MEMORANDUM

From:	Tina Cuss Ecology Officer		
Service	WBC Ecology	App No:	242910
Address:	East Court, Jubilee Road, Finchampstead, Wokingham, RG40 3SD.		
Proposal:	Application for submission of details to comply with the following condition of listed building consent 233044 dated 08/02/2024. Condition 4 relates to details of the roof.		
Type of Development:			
Site Visit Made:	No

Figure 4: Approximate locations of roosts

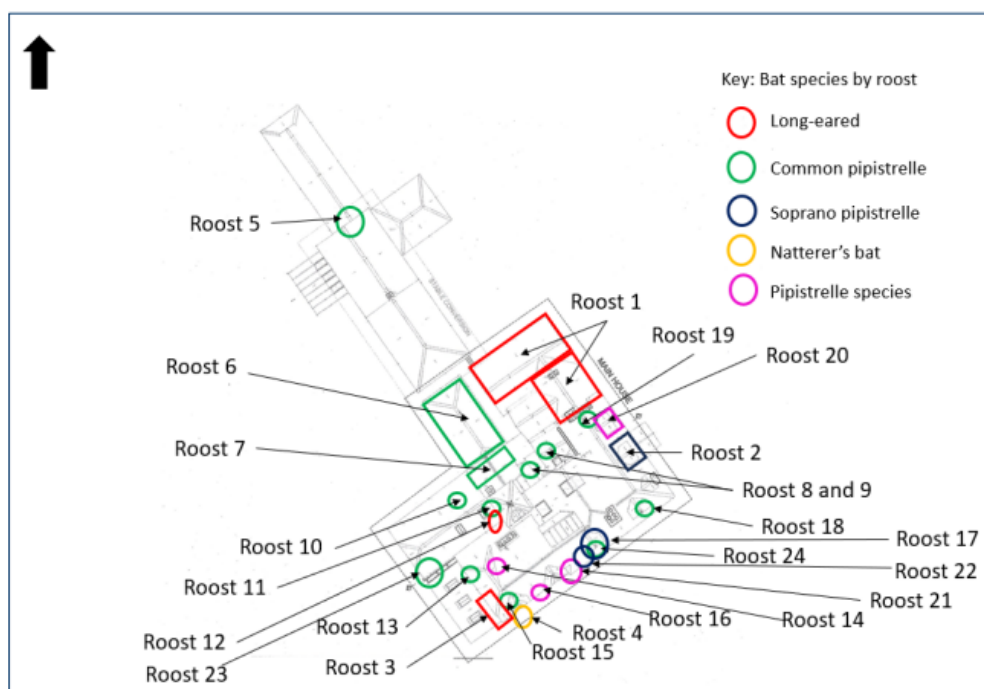
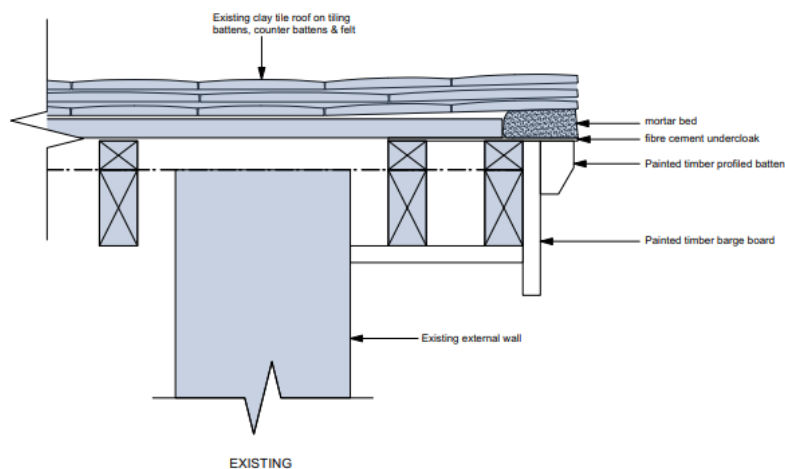
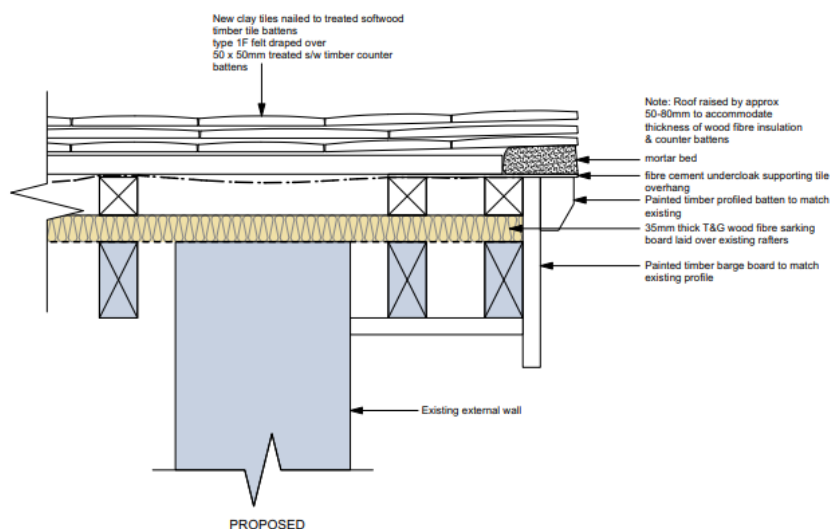
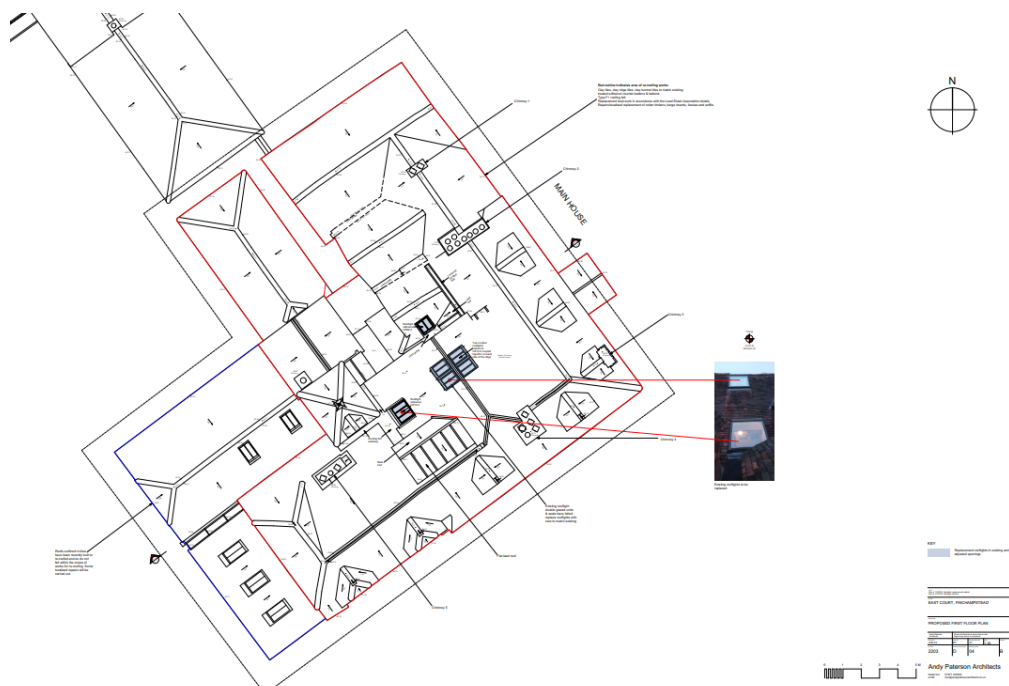
During the preliminary roost assessment evidence of bats was found within each of the loft voids. Several entry points to the main property were noted, including raised roof tiles, decaying bargeboards, and other gaps at connecting points. Roost 1 and roost 3 are used by a maternity colony of Brown long-eared bats. The majority of the other roost access features are day roosts for individual bats. These roost access points are used by four bat species (soprano pipistrelle, common pipistrelle, brown long-eared bat and Natterer's bat). The maximum number of bats using the farmhouse and stable complex counted to emerge on one survey was 32. Roost 4 was used on one occasion by a Natterer's bat. Due to the complexity of the roof on the farmhouse there are areas which neither a camera nor a surveyor could adequately observe. During 2024 update survey four new roosts were identified, including one small maternity roost for common pipistrelle bats. With this information there are now 36 roost access points equating to 24 roosts.

VERGE - EXISTING & PROPOSED

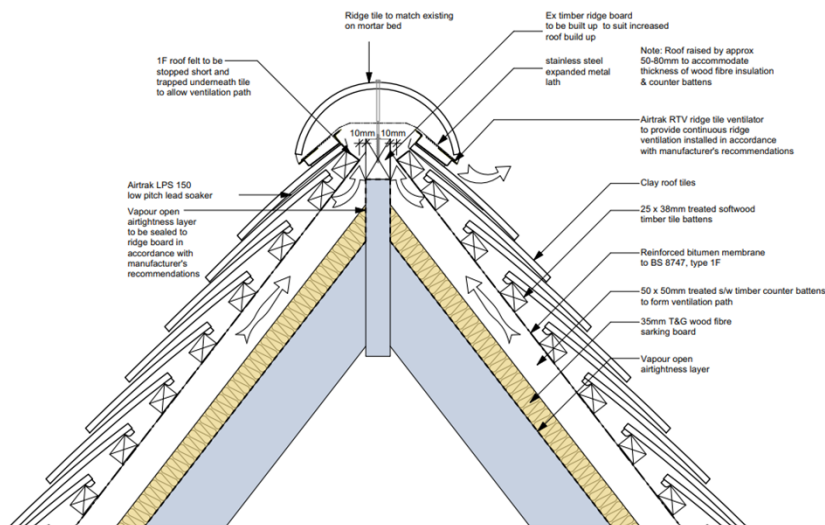
I would not currently recommend approving submissions Eaves – Existing (Andy Paterson Architects Dwg 2203 A 50), Eaves – Proposed (Dwg 2203 A 51), and Verge - Existing & Proposed (Dwg 2203 A 52) and the covering letter sections on treatment of gables, insulation, treatment of eaves, verges and ridges and means of ventilating the roof unless confirmation is provided that the Ecologist named on the earned recognition licence has approved the materials and details of treatments and the access points missing the drawings have been included in the proposals. None of the cross section proposed drawings show the bat access gaps or tiles. I note that the new tiles on the verges shown in Dwg 2203 A 52, are to be nailed on which is not a like-for-like replacement as proposed.

Awaiting confirmation that Dwg 2203 A 50, 51 and 52 have been agreed by Natural England and the Ecologist and provision of detail of the bat roost access points and potential roosting features for crevice dwelling bats to ensure the favourable conservation status of all bat species on site is maintained and wildlife is enhanced.
